Homework Answers

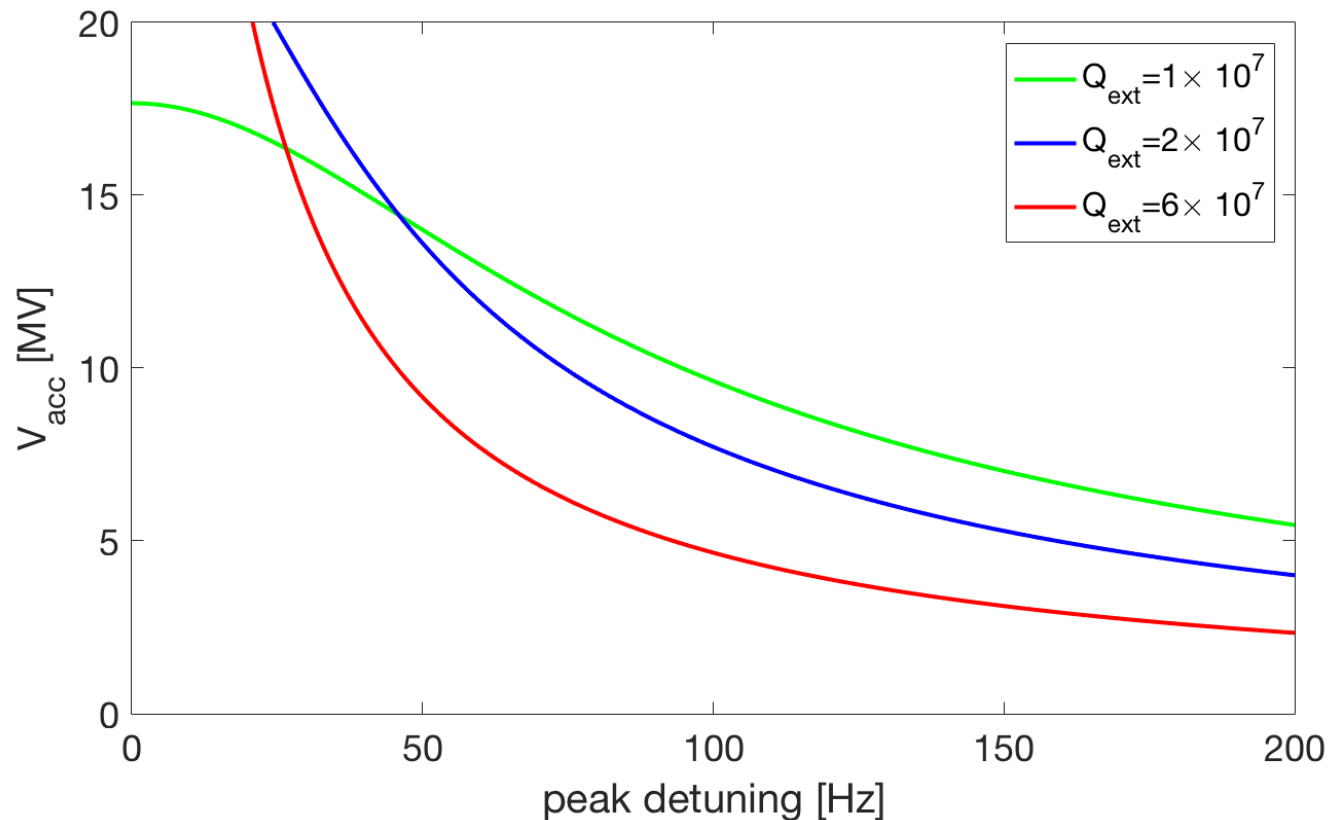
9. What is the strategy to run the MLC if the microphonics cannot be reduced (cavity #3)?

- 1) lower Q_{ext} with 3-stub tuner. The graph shows the max accelerating voltage for one cavity vs. peak detuning, assuming 10kW RF power.
- 2) reduce voltage and run other cavities with smaller detuning at slightly higher voltage.
